RANDWICK CAMPUS REDEVELOPMENT STAGE 1

APRIL 2019

SUMMARY OF FEEDBACK

VIEW FROM BOTANY STREET

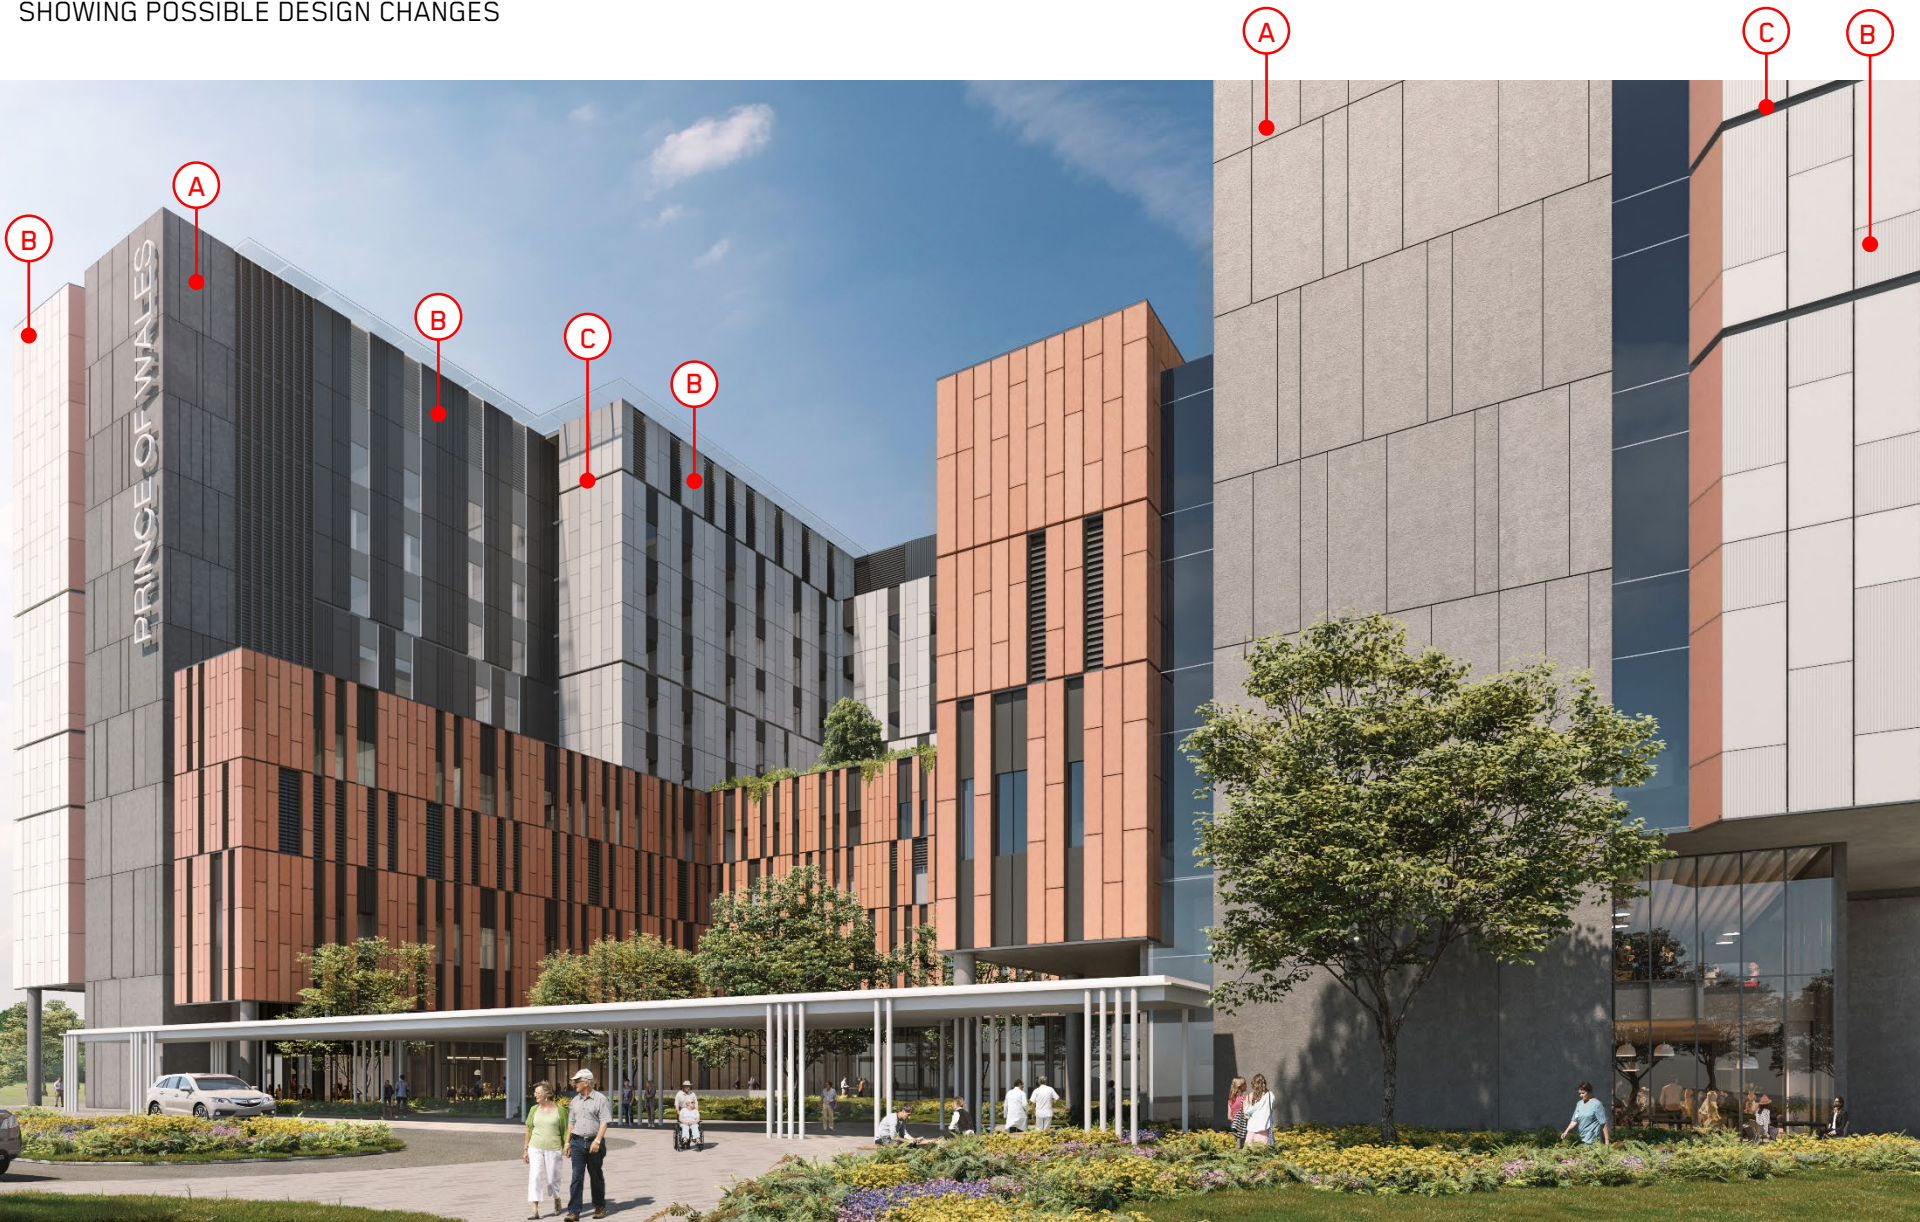
- A. Increase quantity of joints to concrete core walls, and consider adjusting depth and/or width of joint profile.
- B. Include a combination of flat and textured panels in curtain wall.
- C. Replace flush horizontal joints with recessed joints.

VIEW FROM HOSPITAL ROAD

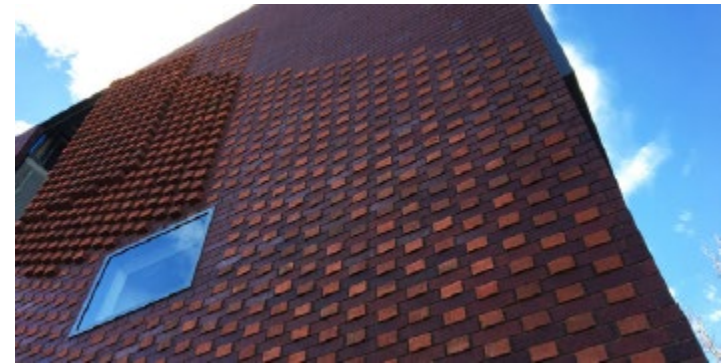
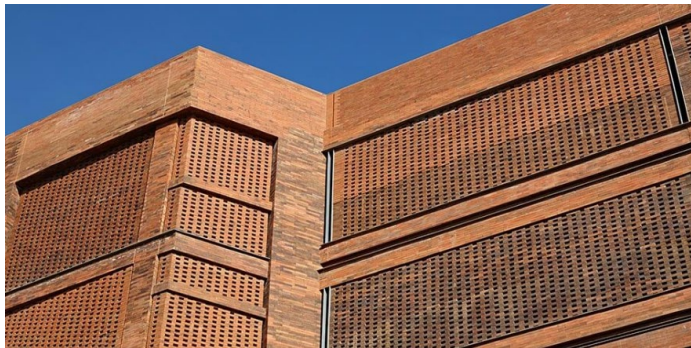
B. Include a combination of flat and textured panels in curtain wall.
C. Replace flush horizontal joints with recessed joints.
D. Addition of 1200mm deep fins to south facade.

E. Enhance expression of precast horizontal joint.
F. Increase texture to brickwork.

EMERGENCY CAR PARK

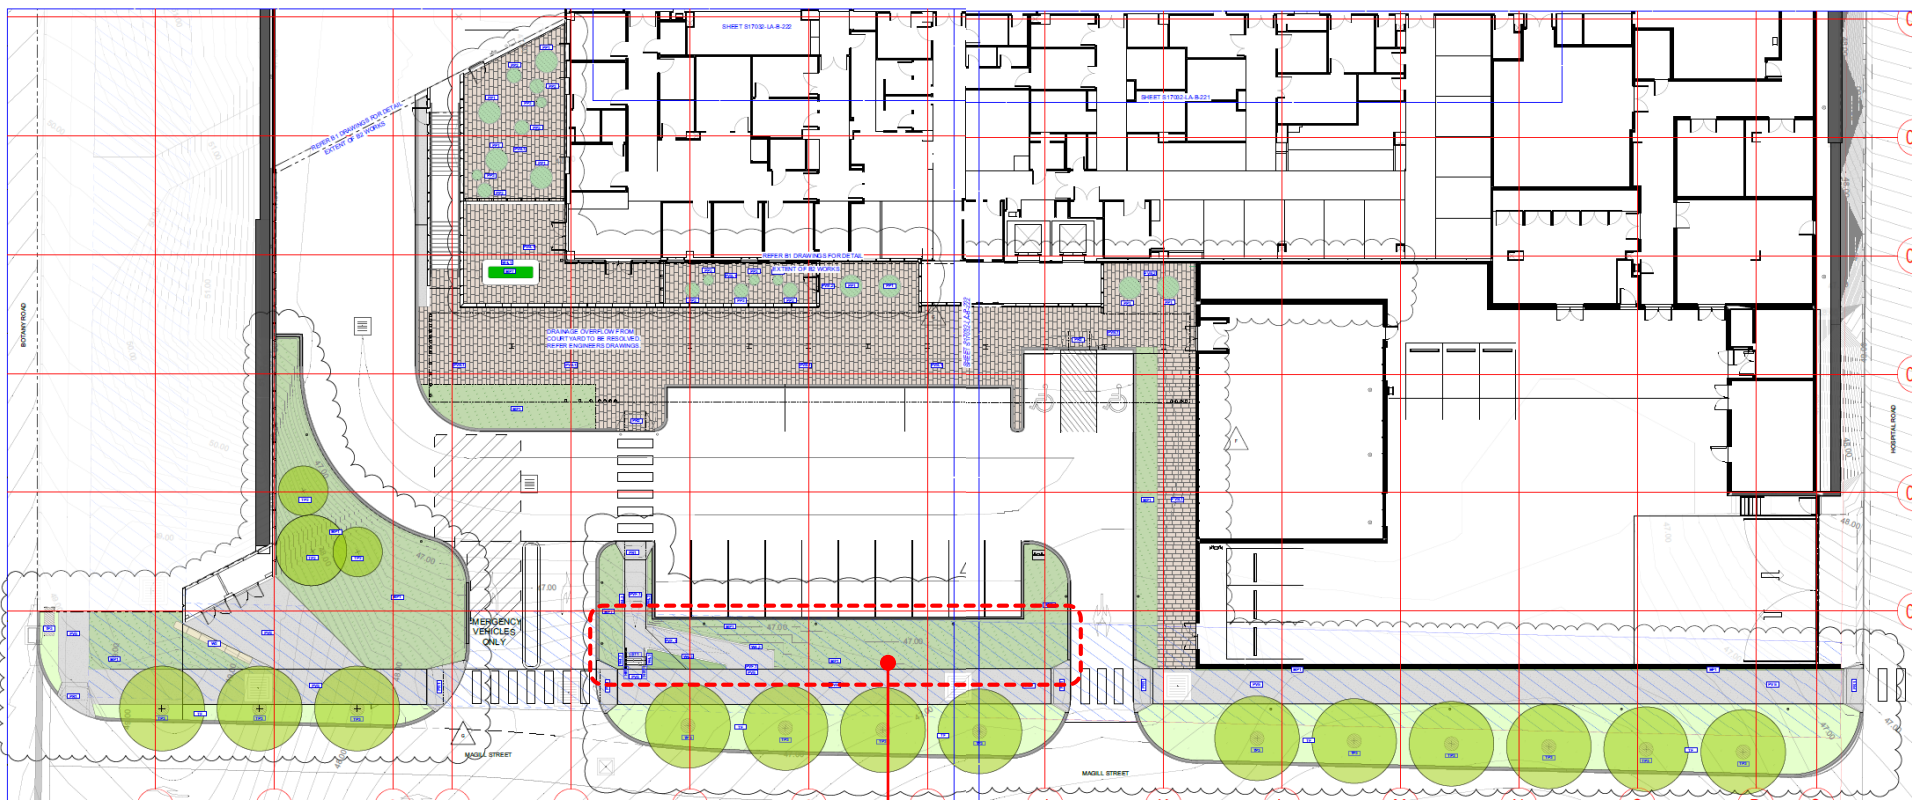
INTRODUCE A ZONE FOR NEW LANDSCAPE
MOUND AND LOW HEIGHT PLANTING TO LIMIT
LIGHT SPILL ONTO MAGILL STREET
